BLM SCALAR FIX -Based on findbhudda's original design:
<http://www.midibox.org/dokuwiki/doku.php?id=findbhudda>

Corrected blm-scalar v1.1.brd below & attached: [blm-scalar_v1.1.zip](#)

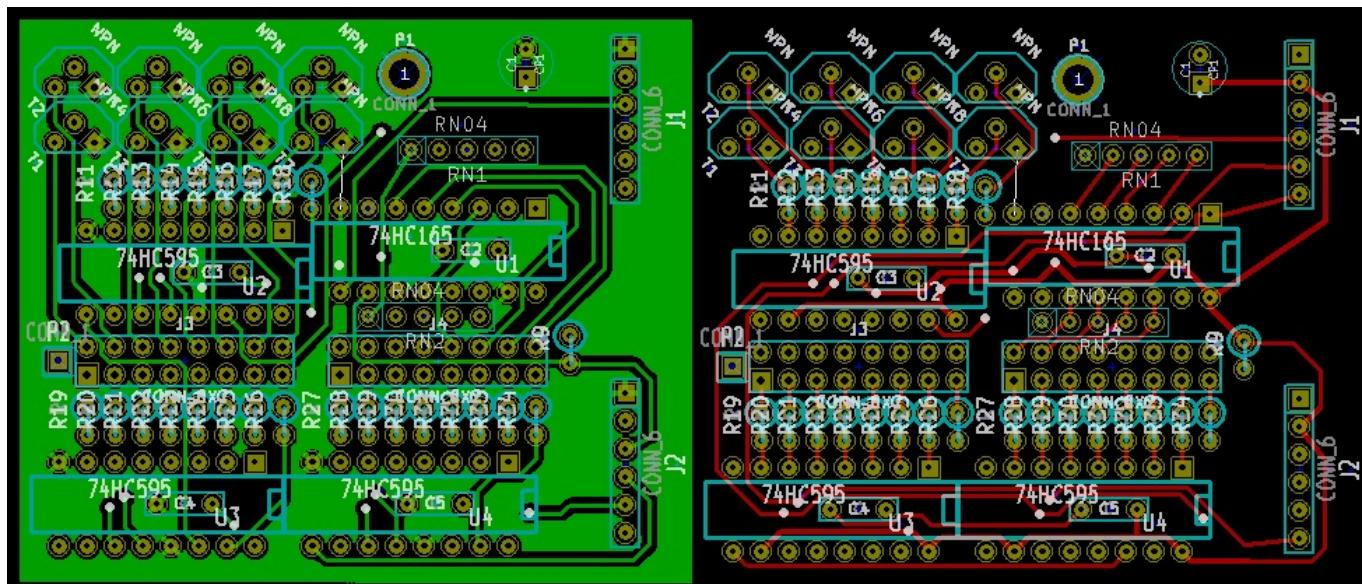
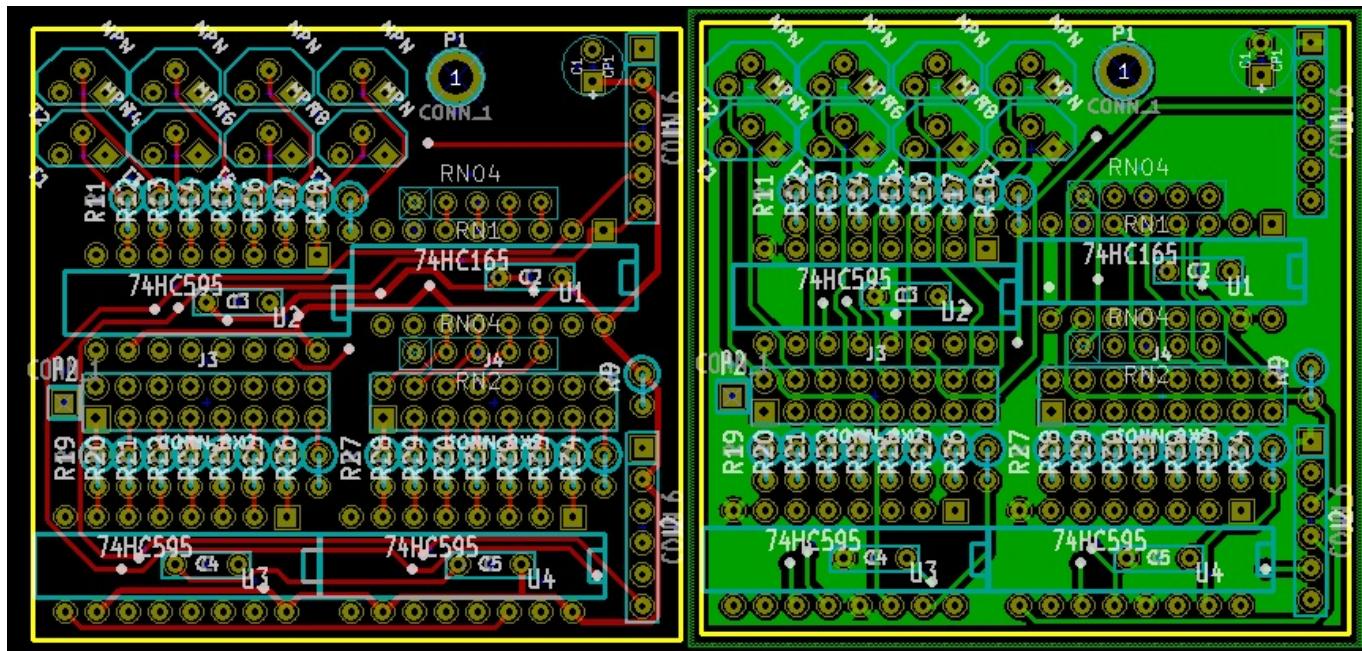
- blm-scalar.* contain an error. Pins I4-I7 are mirrored. This is easily fixed with a connector modification, and the blm-scalar module seems to work as intended.
 - blm-scalar v1.1 attempts to fix this error. Moved connectors J1, J2, Resistor Net 1 and R9 to make room for corrections.
-
